Global MX-5 Cup Car Technical Service Bulletin #05-23-2017

Optional: 2017 Global MX-5 Update: Front Sway bar mounting hardware

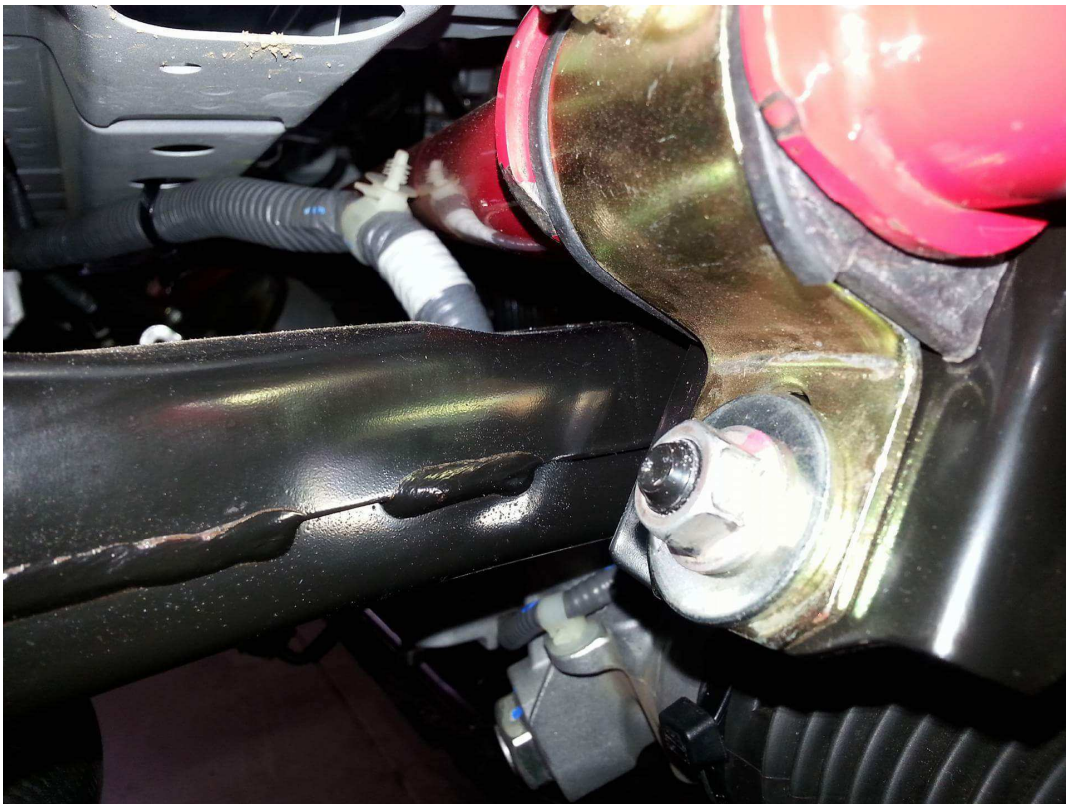
1. The front sway bar mounting bracket may become stressed or fatigued, you have the option of using a larger diameter washer (see picture below).

1. Remove and replace front sway bar nut and washer, replace with a larger diameter washer. Use thread sealant and torque the nut to 15 – 18 foot pounds
